CRS-27-08

Report of survey and Japan proposal on
Labeling of Para 4.5.

JASIC

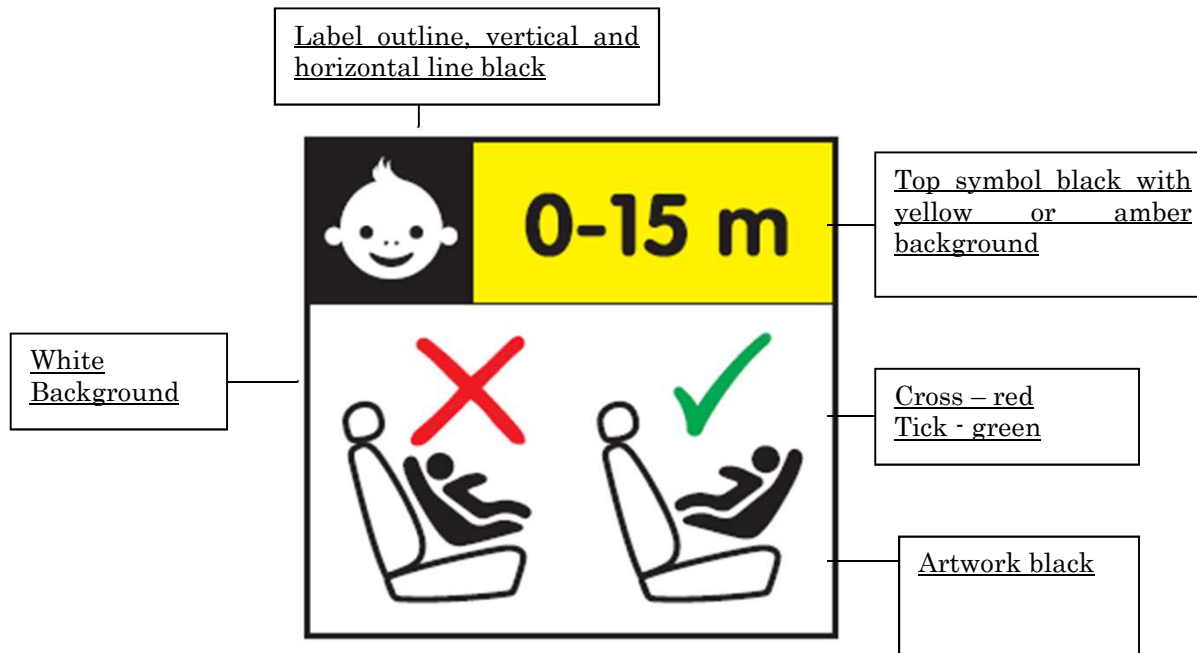
However, if it is understandable sufficiently to the people of several language spoken country or region with only one label, we propose to allow manufacturer to choose to add supplement by commonly used language or not to add supplement.

We also propose to revise pictogram of Group Proposal Label to improve the visibility and reduce misunderstanding.

We want to make it manufacturer's choice, because the label occupies a big area (40mm x 40mm) on car seat's visible zone , it maybe difficult to make it mandatory to put supplement due to size.

- 4.5. In the case of Child Restraint Systems that can be used forward facing, it shall have the following label permanently attached and visible to someone installing a child restraint in the vehicle (**the information shown is a minimum. Manufacturer is allowed to add supplement in the label if necessary. Supplement language should be commonly spoken language in the country or region where product is to be sold**):

label minimum size 40 x 40 mm
